**NW Natural ISS Field Pilot Study Implementation
Gasco Sediments Site – September/October 2023
Field Change Request Form**

Project Name: Gasco Sediments Site **Contractor:** Sevenson Environmental Services, Inc.

Field Activity: ISS Field Pilot Implementation **Request Number:** 1

Field Change Request Title: Repositioned ISS Pilot Study Footprint and Post-Construction Sand Placement

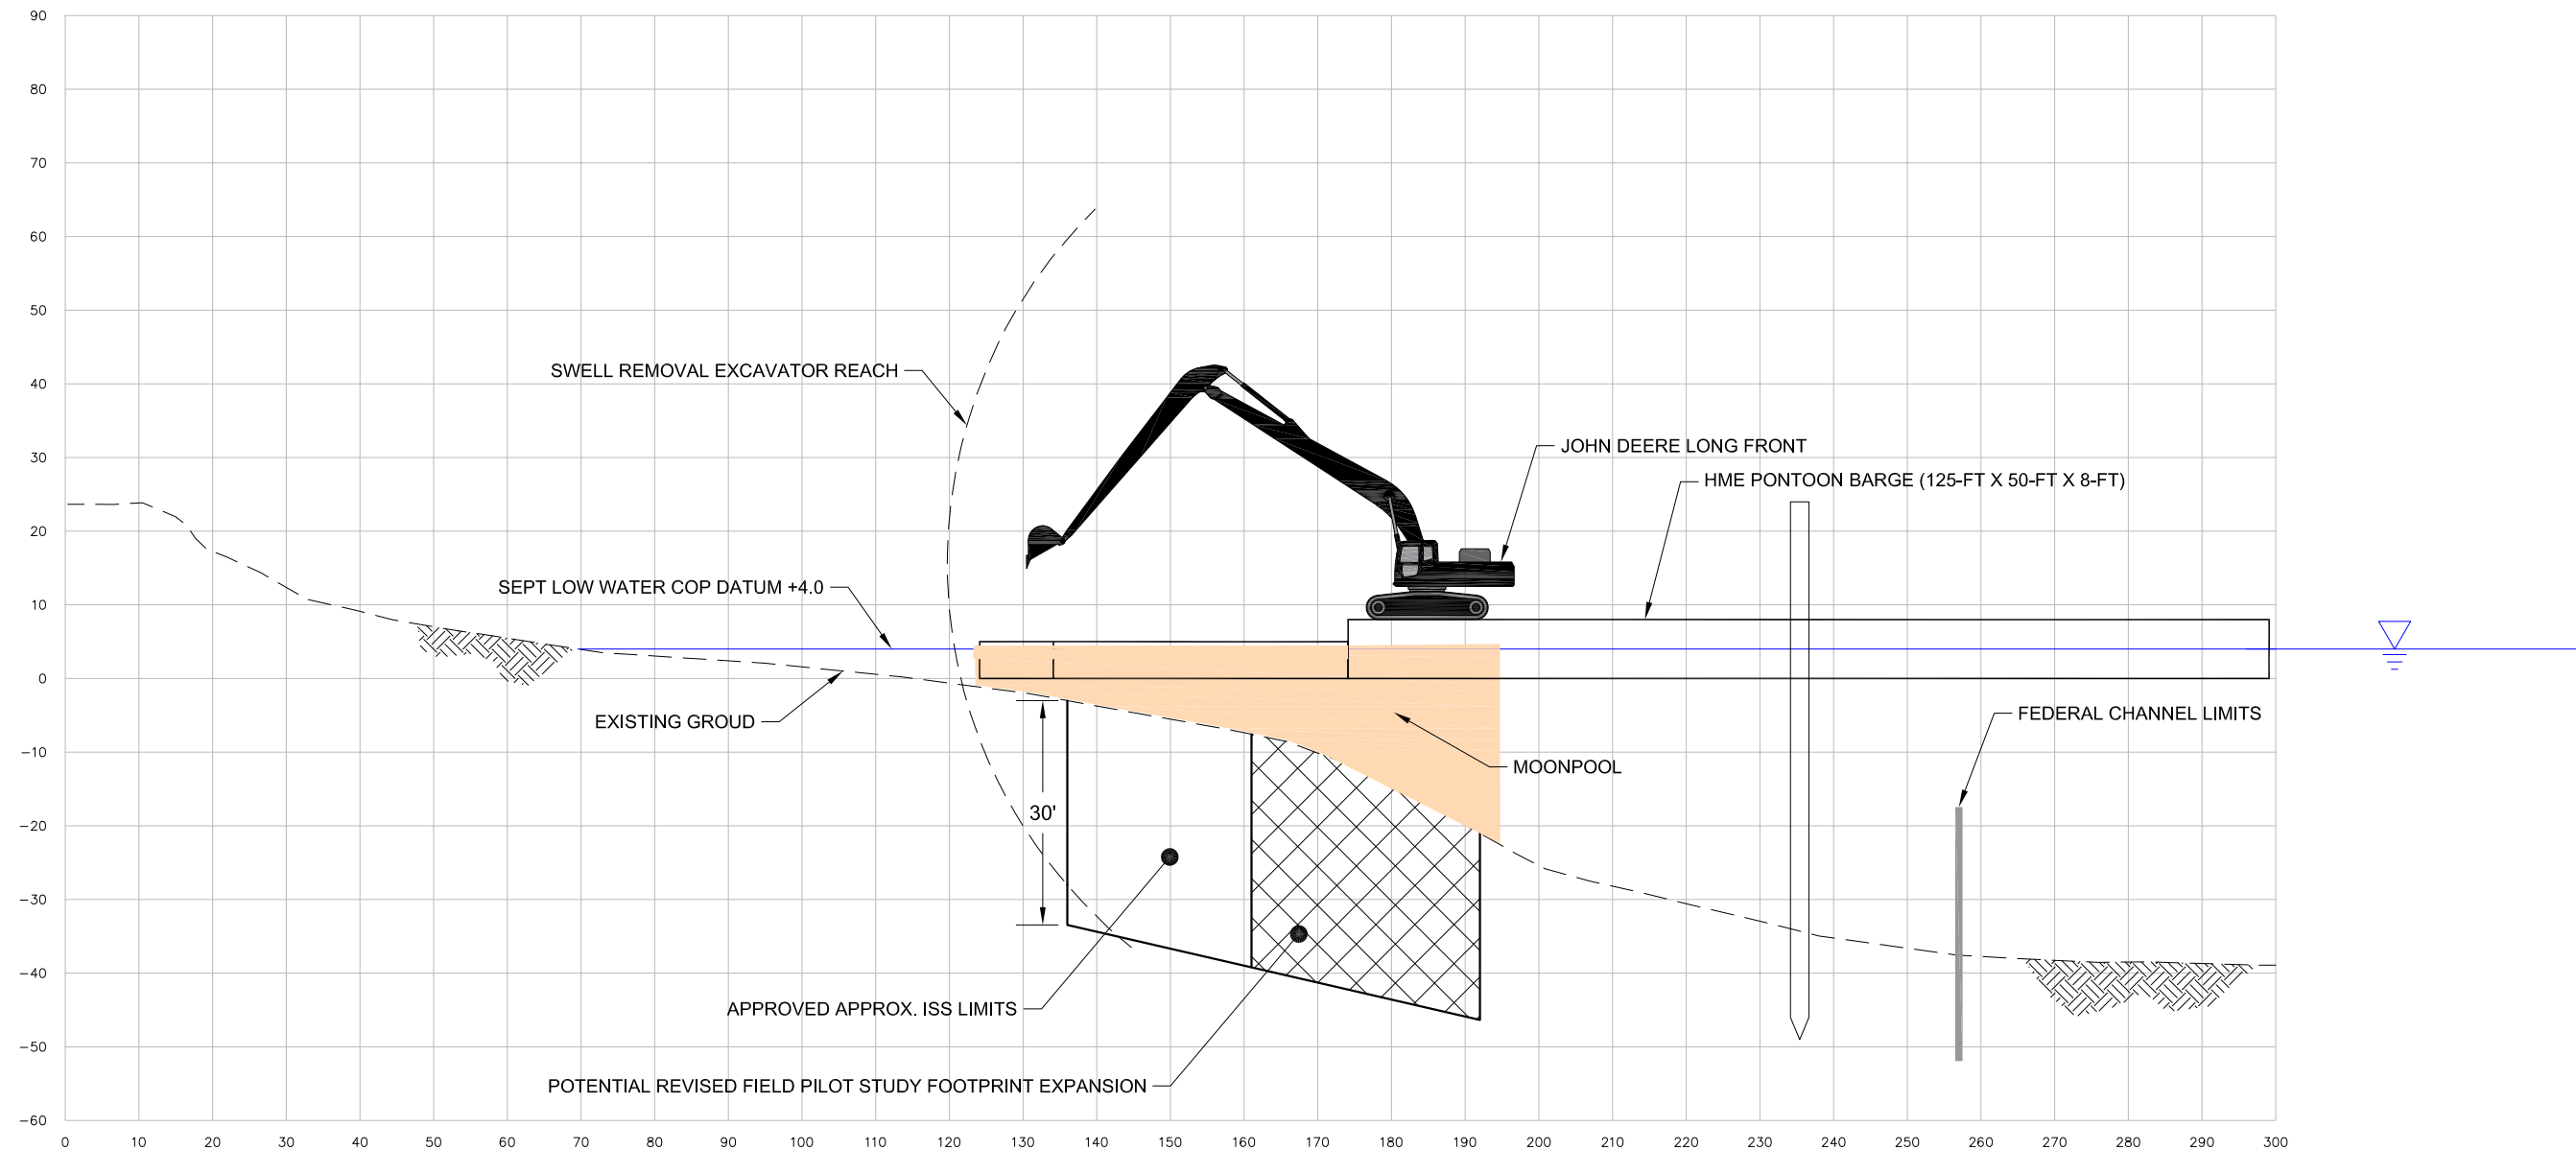
In addition, following 2 days of targeted removal of surface and subsurface debris within the FPS area prior to initiation of ISS auguring, additional previously unidentified subsurface debris were encountered at variable depths below mudline in several columns completed to date in row 1 of the FPS area (Figure 1). This debris comprised timber pilings and large cobbles. In four of the column locations (1-4, 1-5, 1-8, and 1-9), the presence of this debris prevented achievement of ISS treatment to the full target 30-foot DOC.

NW Natural requests the flexibility to reconfigure the FPS area to allow ISS column placements within the approximate extents shown in Figure 1. The total number of columns that will be advanced cannot be determined at this time, but the goal is to advance the minimum number (29) identified in the Work Plan. Figure 2 shows a profile view of this potential full expansion in the channelward direction. As discussed with EPA, the Design Team will determine whether and to what extent expansion is necessary based on river elevations encountered, the results of additional ISS auguring, and associated debris removal within the EPA-approved FPS area in the next few weeks. Now that NW Natural has successfully completed multiple days of ISS auguring with associated field and chemistry water quality monitoring data showing no exceedances of the applicable criteria, the Design Team will focus on performing additional debris removal either within the current or expanded FPS area and testing additional means and methods to clear areas with obstructions to ISS auguring. Consistent with Appendix D of the Work Plan, water quality monitoring will be performed in accordance with changes in construction activities.

FIGURE
2

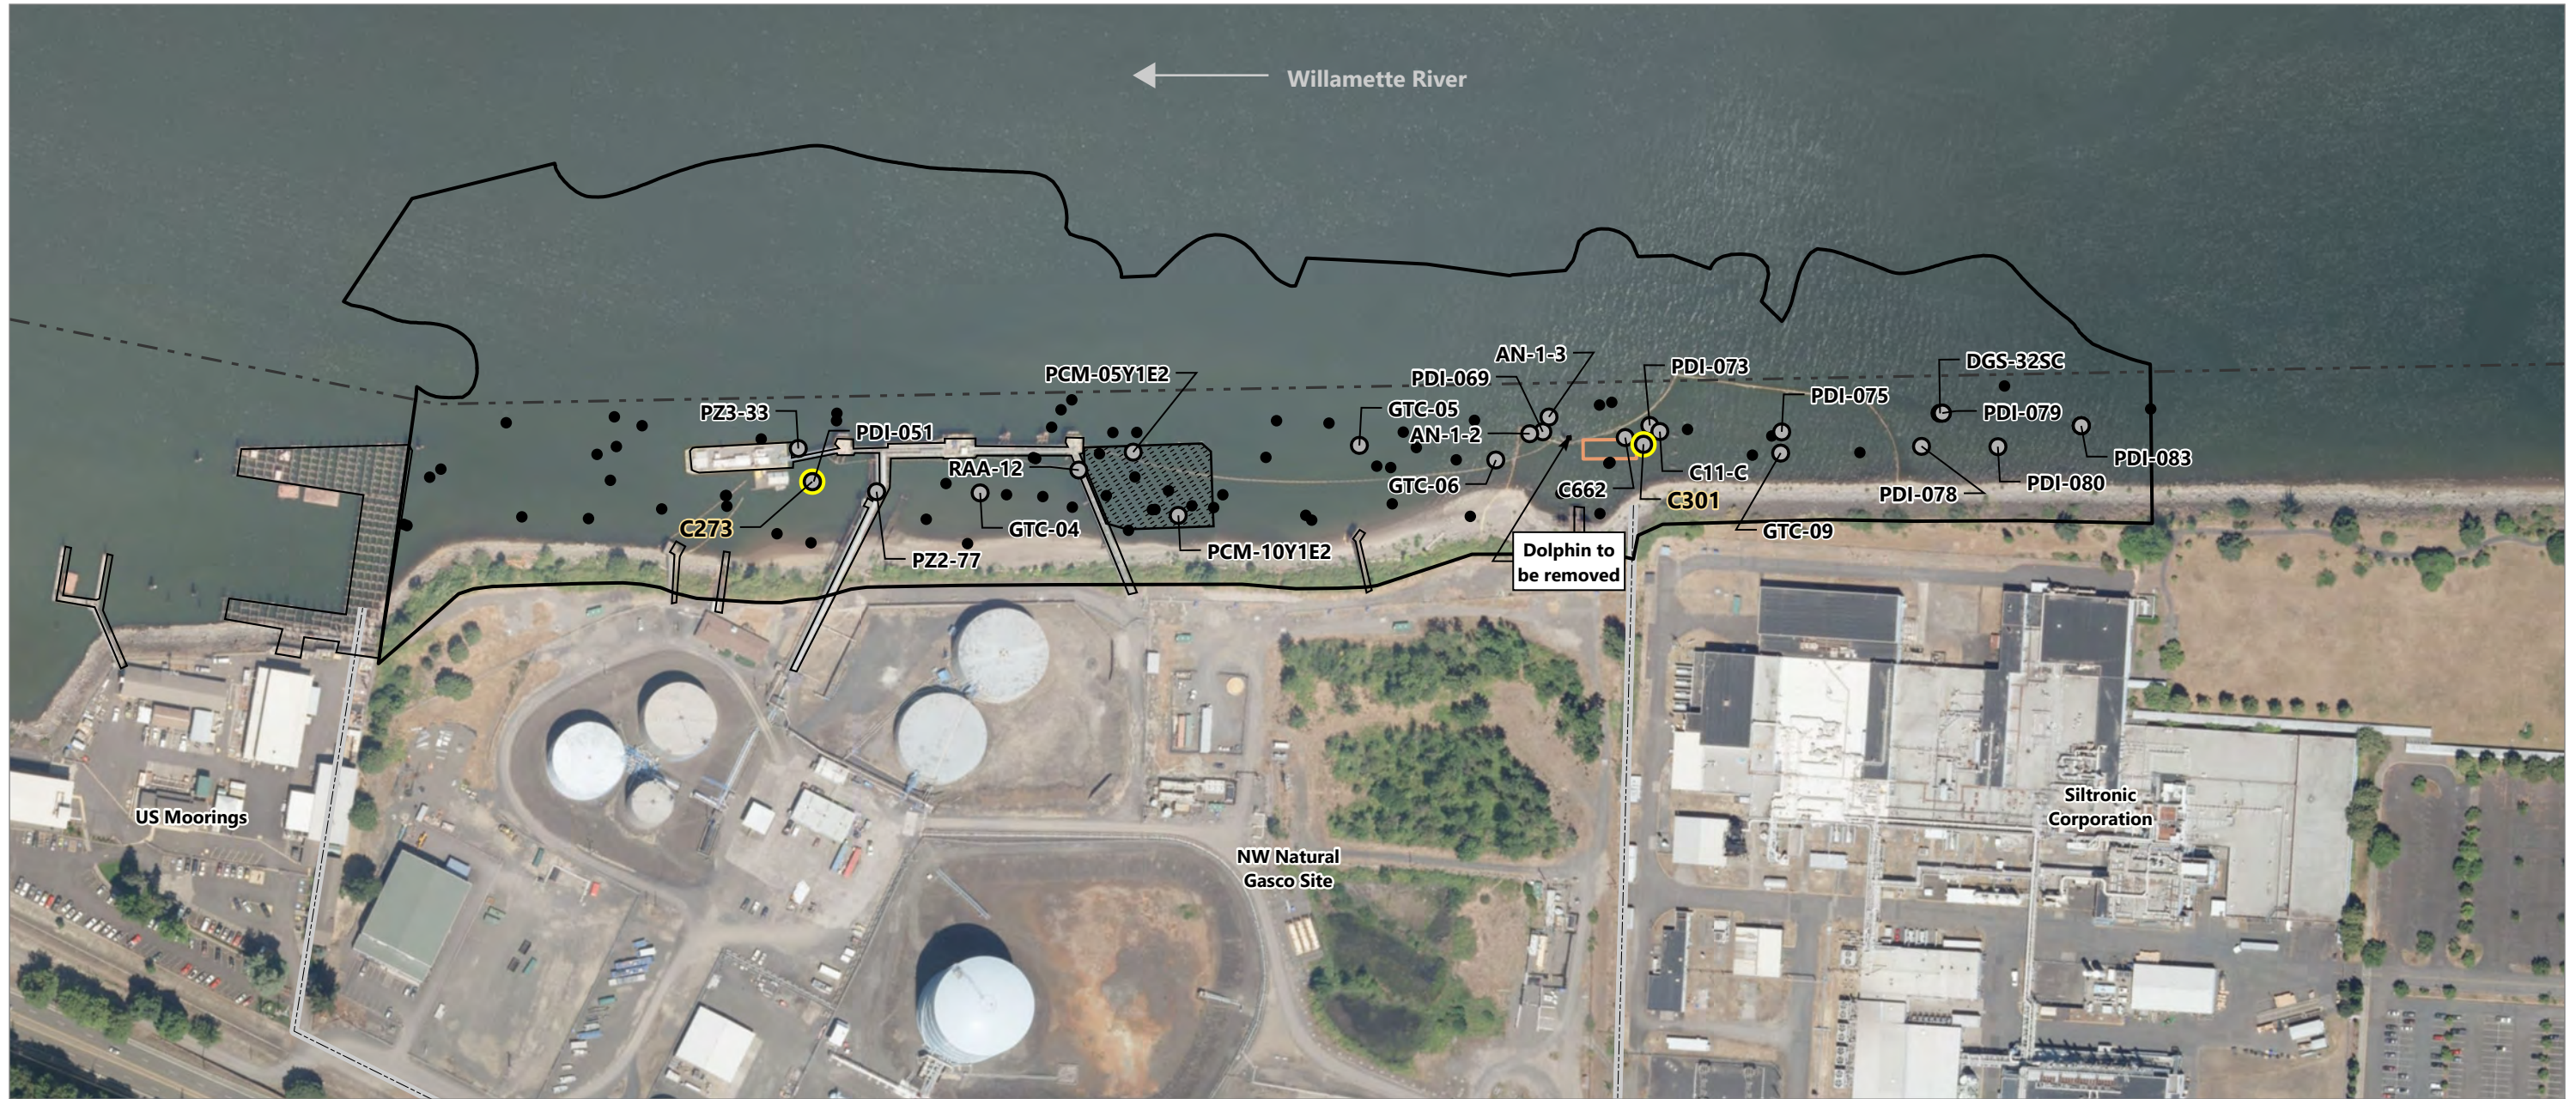
- Remains directly adjacent to ISS bench scale treatability location ISSTS-003 (see Work Plan Figure 3-2 in Attachment A).
- Remains sufficiently offset from the navigation channel such that no work will occur in the 10-foot offset (Figure 2).
- Relocates the ISS footprint closer to subsurface sediment core location PDI-198 where the DOC is 17 feet below mudline (see attached Work Plan Figure 3-3 in Attachment A). To maintain the same level of conservatism identified in Section 3.1 of the Work Plan, NW Natural will maintain the originally proposed DOC of 30 feet below mudline in any expanded FPS area column location.

Figure 3-1a
PTW-NAPL Observations: 0 to 4 Feet
 Final Revised in Situ Stabilization and Solidification Field Pilot Study Work Plan
 Gasco Sediments Project Area
GASCO0054079

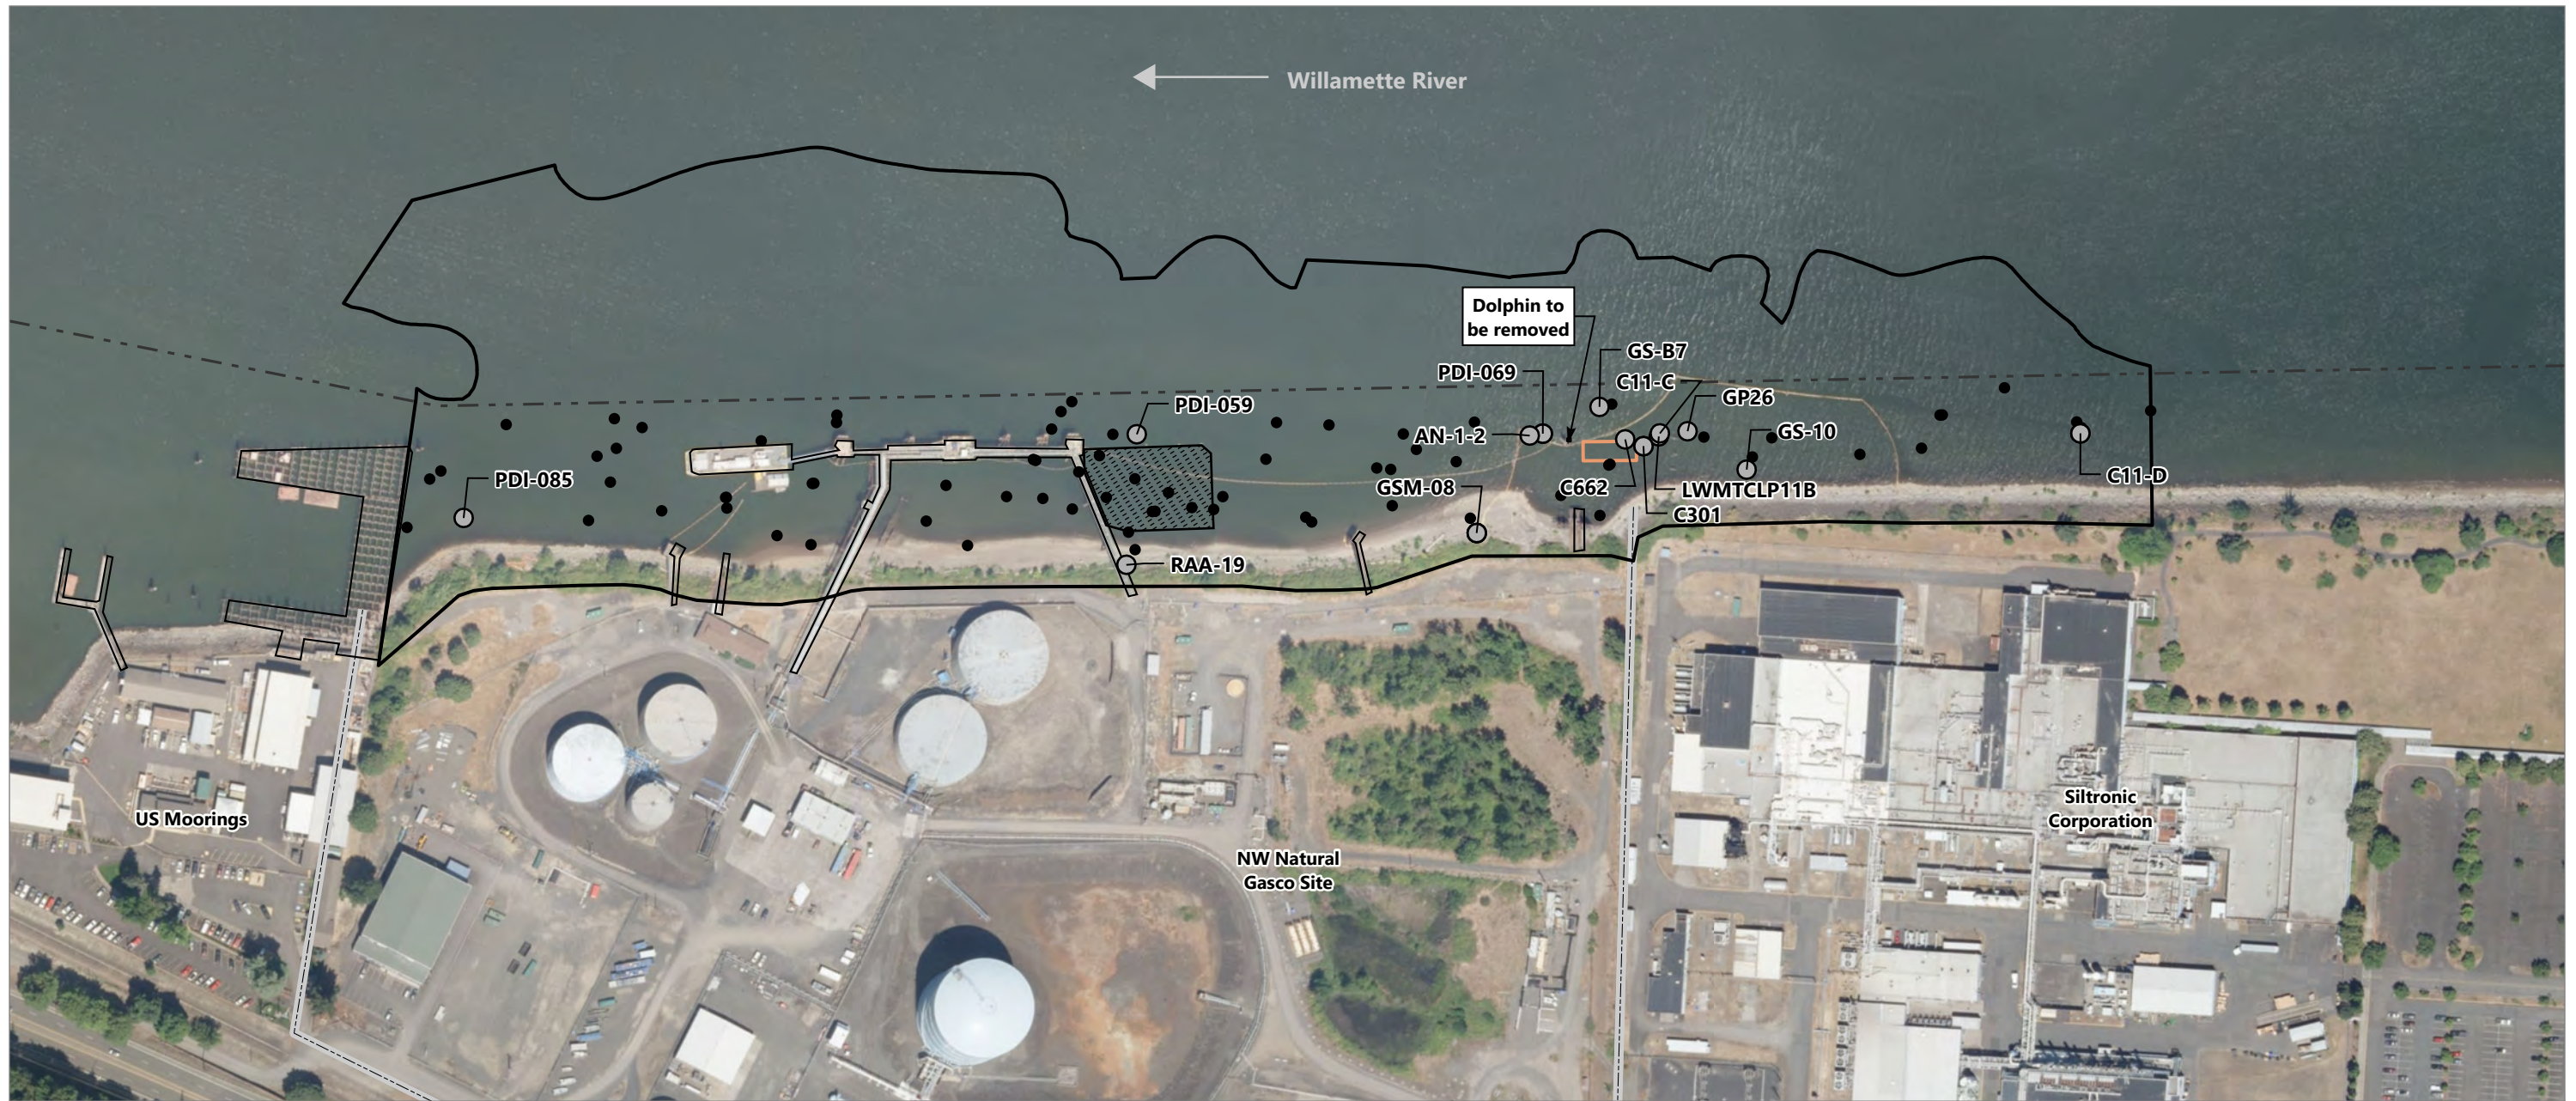
- PTW-NAPL has been observed inside the expanded FPS area (see Work Plan Figure 3-1a in Attachment A).
- The grain size distribution is expected to be comparable to what was observed in the original FPS area because the expanded FPS area is directly adjacent.
